MUL-T-LOCK®

Tech. Update

No. 242

New 2 in 1 rotation limiter for cam lock 19

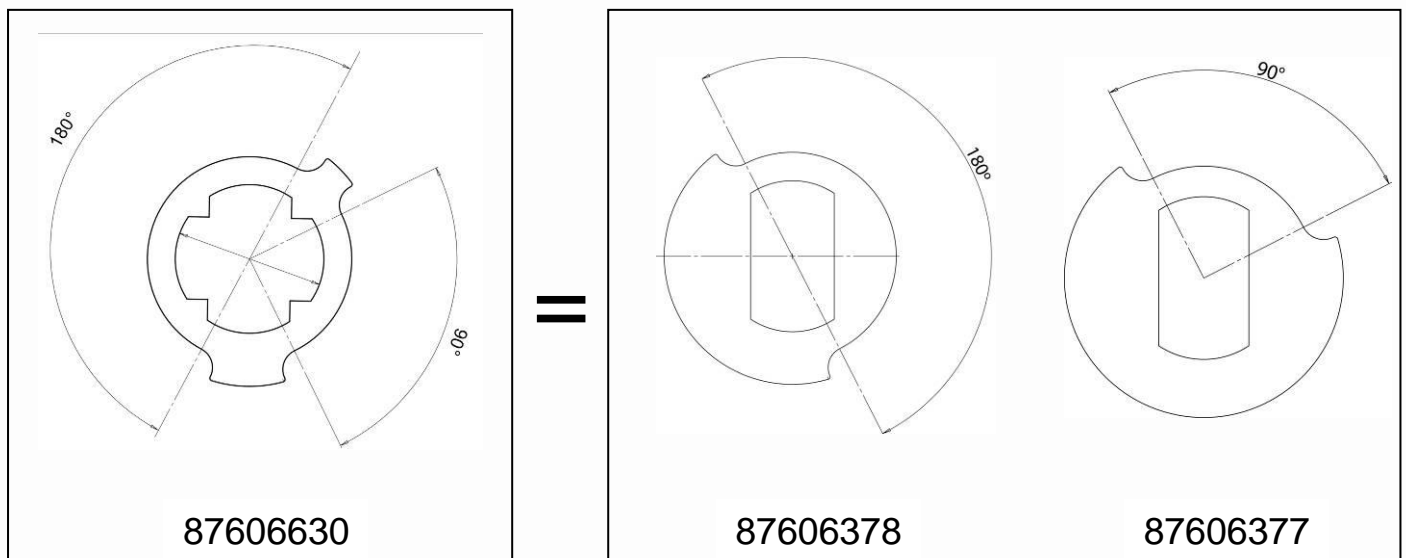
In our constant product evaluation process we have combined 2 rotation limiters 90° and 180° into 1 for the 19 mm key retaining cam lock.

You can use it as 90° and 180° by flipping it over.

This action will reduce the need to deal with 2 different rotation limiters in stock.

The new rotation limiter P/N 87606630 will be supplied with final products or in kit P/N 87666014 immediately after we will finish consuming the old stock (87606378 & 87606377).
